## PRELIMINARY REVIEW

## NEW BEDFORD HISTORICAL COMMISSION MEETING March 5, 2018

ADDRESS: 42-46 N Water Street (Map 53 Lot 180)

Existing exterior ductwork located at the rear of 42-46 N Water Street as visible from Centre Street.

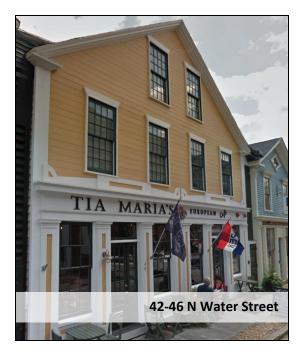
Updated building codes require certain clearances for exhaust ductwork relative to windows, roof lines, and air intake vents due to fire safety. Recognizing the need for restaurants to meet code requirements as part of their commercial operations, the NBHC has asked property owners at a minimum to paint the ductwork in an effort to mitigate visibility. In several instances, shaft enclosures were utilized to house vertical ductwork, acting as a chimney. The NBHC and the property owner should explore applicable means within the building code to mitigate the view of the existing exterior ductwork from Centre Street and seek a Certificate of Appropriateness for such work.
